From: Wight, Brian <brian.wight@aecom.com>
Sent: Tuesday, January 09, 2018 11:11 AM
To: jorge.jacobs@ks.gov
Cc: Chrysler, Ruby; Mark D. Wichman (mark.d.wichman@usace.army.mil); KNIGHT, COLE D GS-11 USAF AMC 22 CES/CEAN (cole.knight@us.af.mil); Sansom, Andrea NWO; michael.d@ageiss-inc.com; 'Jose.hurtado@us.af.mil'; GUTIERREZ, NEYDA V CTR USAF AFMC AFCEC/CZR; Julie Spencer; Mike L. Schofield (mlschofield@gsi-net.com); Krause, Michael; Mowan, Ryan; Bergantzel, Vanessa
Subject: McConnell AFB PBR: Responses to KDHE Comments on Final SS544 (SWMU107) RFI
Attachments: SS544_FNL_RFI_RTCs (KDHE).docx
Categories: Record Saved - Shared

TECHNICAL REVIEW COMMENTS
McConnell AFB PBR
W9128F-13-C-022
SS544 (SWMU 207)
Final SWMU No. 207 (SS544) RCRA Facility Investigation Report
McConnell Air Force Base, Wichita, Kansas
Date of Comments: 1 December 2017

Figure 1. Ramp 400 area showing RFI sample locations.

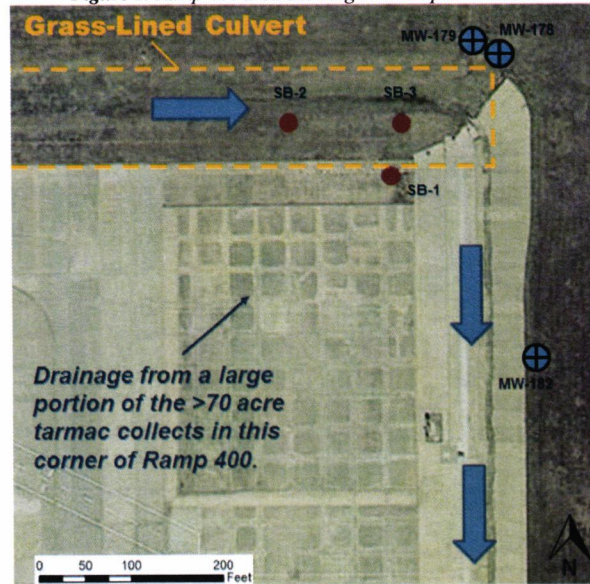
1. The identification of the Ramp 400 Area as a potential source for VOC contamination is not adequately supported by groundwater data presented in this report and the lack of detected VOCs in the soil samples collected in this area.

URS Response: At the Ramp 400 area, the suspected release mechanism of contaminants of concern (COCs) to groundwater is the infiltration of storm water (surface runoff) containing dilute concentrations of COCs from a large portion of the Former Boeing tarmac, a >70 acre area with a long history of aircraft maintenance activities. The following lines of evidence support our proposed conceptual site model (CSM) for Ramp 400:

- 1) Storm water runoff from the Former Boeing tarmac is directed north towards the grass-lined culvert and then south along the concrete-lined culvert (see **Figure 1**). Field observations during RFI sampling events confirmed pooling of water in the grass-lined culvert during/after a storm event. Surface runoff entering the grass-lined culvert has the potential to infiltrate the subsurface (and the underlying paleochannel deposits), serving as a source of COCs during historical maintenance activities on the tarmac.

- 2) The distribution of contaminant mass in groundwater in the paleochannel deposits is centered in the Ramp 400 area. Specifically, local maximum concentrations of Carbon Tetrachloride (see Figure 3-8 of the RFI report), 1,1 Dichloroethene (see Figure 3-9 of the RFI report), and Trichloroethene (see Figure 3-10 of the RFI report) were identified at monitoring well MW-178, located alongside the grass-lined culvert of the Ramp 400 area (see **Figure 1**). Elevated concentrations of these COCs were also detected at other Ramp 400 monitoring wells (MW-34, MW-179, MW-180, MW-182).

- 3) Benzene and Toluene were detected in soil samples from boring SB-3 during the RFI (see Table 3-3 of the RFI report). This is consistent with our proposed CSM for Ramp 400, where contaminated runoff consists of a mixture of various COCs infiltrated the subsurface.
